**PLANNING APPROVAL,  
PLANNED UNIT DEVELOPMENT &  
SUBDIVISION STAFF REPORT**

**Date: November 17, 2011**

<b><u>NAME</u></b>	New Hope Baptist Church
<b><u>SUBDIVISION NAME</u></b>	New Hope Baptist Church Subdivision
<b><u>LOCATION</u></b>	1270 & 1272 Pecan Street, 605 & 608 Live Oak Street, 1261 & 1263 Persimmon Street (Northeast corner of Pecan Street and Live Oak Street extending to the Southeast corner of Pecan Street and Persimmon Street; and West side of Live Oak Street, 120'± South of Persimmon Street)
<b><u>CITY COUNCIL DISTRICT</u></b>	District 2
<b><u>PRESENT ZONING</u></b>	R-2, Two-Family Residential District
<b><u>AREA OF PROPERTY</u></b>	1 lot / 3.4± acres
<b><u>CONTEMPLATED USE</u></b>	Planning Approval to allow the expansion of a church and construction of off-site parking for church use in an R-2, Two-Family Residential District; Planned Unit Development approval to allow reduced front yard setbacks and side-street side yard setbacks and off-site parking; and Subdivision approval to create two legal lots of record.

SITE PLAN

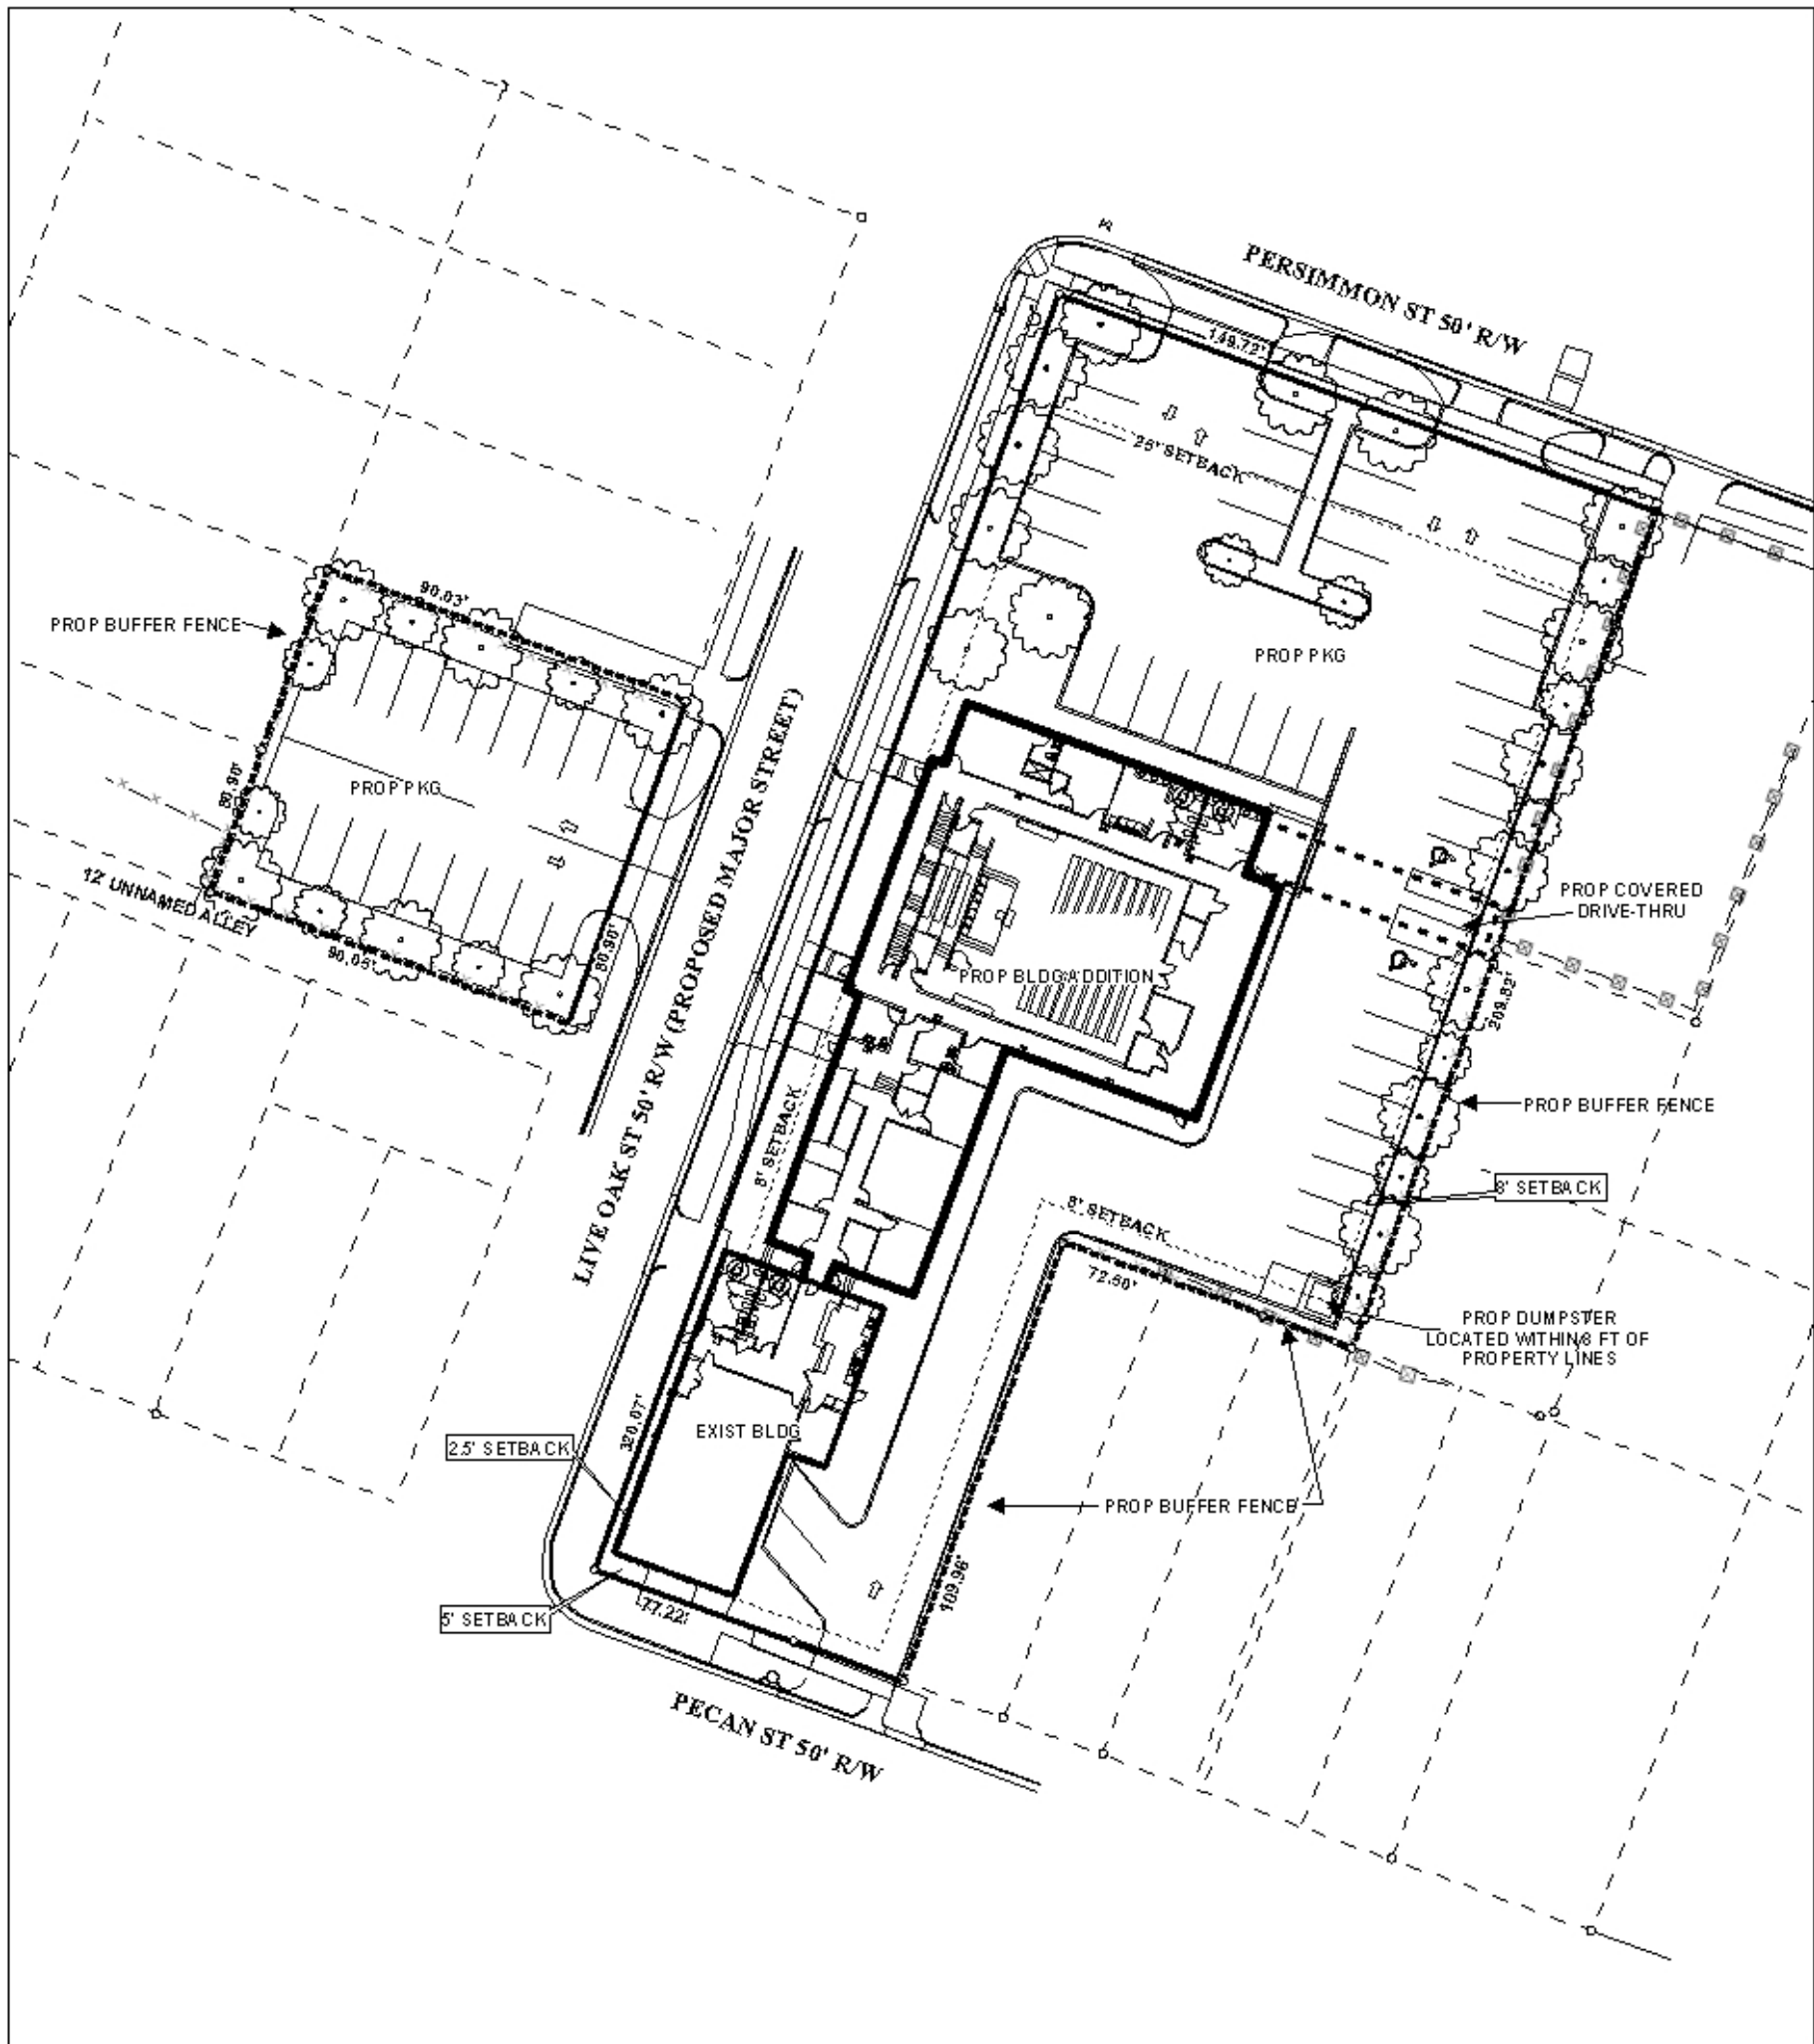
Driveway number, size, location, and design to be approved by Traffic Engineering and conform to AASHTO standards. Driveway access to Persimmon Street should be limited to one driveway, centrally located to avoid conflict with the adjacent speed bumps in the roadway. The proposed driveway on Pecan Street should be narrowed to 14'-16' for one-way traffic. There is no other indication that the aisle is one-way northbound, other than the arrow at the driveway. Aisle should be designated as one-way and wrong way vehicles should be deterred from entering, using angled parking for example. Traffic Engineering is concerned with the line of sight through the double 90° turns within the site. The building and privacy fence obstruct the view of oncoming traffic and parking vehicles through the curves. Traffic Engineering is also concerned with the location of the dumpsters and how they will be accessed. Parking stall widths should be 9' minimum for both lots. The 5' offset within the aisle in the northeast corner of Lot 1 should be eliminated, as it reduces the effective aisle width to approximately 20' for two-way traffic.

The proposed layout of the site and improvements presents a problem. The applicant is proposing that the addition have a building setback of 8.5 feet along Live Oak Street. Ordinarily, a 20-foot side-street side yard setback would be required. In this case, however, Live Oak Street, as previously mentioned, is a proposed major street, which requires a 100-foot right-of-way. The existing right-of-way is only 50 feet, therefore, at a minimum, 25 feet should be preserved with a building setback line to prevent any new buildings or additions from being constructed in the future widening area. As such, the reduced side-street side yard should be denied.

The applicant is also requesting a 5-foot front yard setback along Pecan Street, presumably due to the existing non-conforming nature of the existing building. As the existing building is non-conforming, and no new buildings or building expansions are proposed in the area of the property along Pecan Street, there is no need for a reduced setback, and, as such, the request for a reduced 5-foot front yard setback along Pecan Street should be denied.

The applicant has proposed an 8-foot side yard setback along the eastern side of the site. A proposed "covered drive thru" is shown on the site plan. The drive thru is depicted as being within two feet of the side property line. The Zoning Ordinance, as per Section 64-4.D.1. requires, in addition to a buffer fence, a 10-foot restricted use buffer between the site and residentially utilized properties. While parking may be placed within the buffer, structures may

not be. Additionally, the covered drive thru takes up accessible parking space area, and may not be compliance with the Americans with Disabilities Act (ADA). Further regarding the restricted use buffer area, the dumpster, as shown, is located within the buffer. Due to the layout of the site, and the absolute bare minimum amount of parking provided, the dumpster cannot be moved without causing the site to be deficient on parking.

There are also other issues with the site plan, as presented. The layout does not allow adequate space for frontage trees to be planted along Pecan Street and a sizable portion of Live Oak Street. Tree Plantings are required due to the addition being more than 50% or greater in floor area. Further, the two angled parking spaces nearest to Pecan Street on the south end of the site do not appear to allow adequate maneuvering space without having vehicles to back-out into the right-of-way. Also, a covered porch is shown within the right-of-way of Pecan Street, which would not be allowed to remain.

The site plan also does not depict parking lot screening as required by Section 64-4.A.3.i. of the Zoning Ordinance. This screening would be required along Persimmon Street and Live Oak Street due to residential properties across the street. Additionally, the site would need to comply with Sections 64-4.A.2. and 64-6.A.3.c. of the Zoning Ordinance regarding illumination of uses and arrangement of lights so as not to shine directly into traffic or residential properties. Additionally, the off-site parking lot on the proposed Lot 2 does not indicate proper buffering as required by Section 64-4.D.1. of the Zoning Ordinance.

Given this information, and the requests for reduced setbacks, it would appear that this site is proposed to be over-built, and, as such, this site plan should not be approved.

**Planning Approval:** The request is recommended for denial due to the following reasons:

- 1) the site plan, as proposed, has several deficiencies that cannot be corrected due to the possible over-build of the site;
- 2) the site plan is not in compliance with the Comprehensive Plan because of lack of preservation of area for the proposed Cross Town Loop 2 of the major Street Plan.

- 1) depiction of a 25-foot minimum building setback line along the Pecan Street and Persimmon Street frontages;
- 2) depiction of a 40-foot minimum building setback line along the Live Oak Street frontage;

- 5) removal of the 8-foot setback line along the eastern side property line;
- 6) compliance with Engineering comments: *"1. Any work performed in the existing ROW (right-of-way) will require a Right of Way (ROW) permit from the Engineering Department and must comply with all City of Mobile ROW code and ordinance requirements. 2. Any increase in impervious area in excess of 4,000 square feet will require detention. 3. Need engineer's analysis of the capacity of the receiving storm system to ensure that the receiving system is capable of handling the additional flow; or provide minimum detention for the 100 year storm event with a release rate for the 2 year storm. 4. Drainage of onsite runoff from Lot 2 needs to tie into the existing drainage system on Live Oak St instead of tying into the proposed system on Lot 1. 5. At the intersection of Persimmon St and Live Oak St need to provide dedication of a minimum radius of 25', or as otherwise approved by the City Engineer. 6. Any site improvements requiring a building permit will require full compliance with City Code Chapter 57 including repairing any existing sidewalk panels and driveway curb cuts;"*
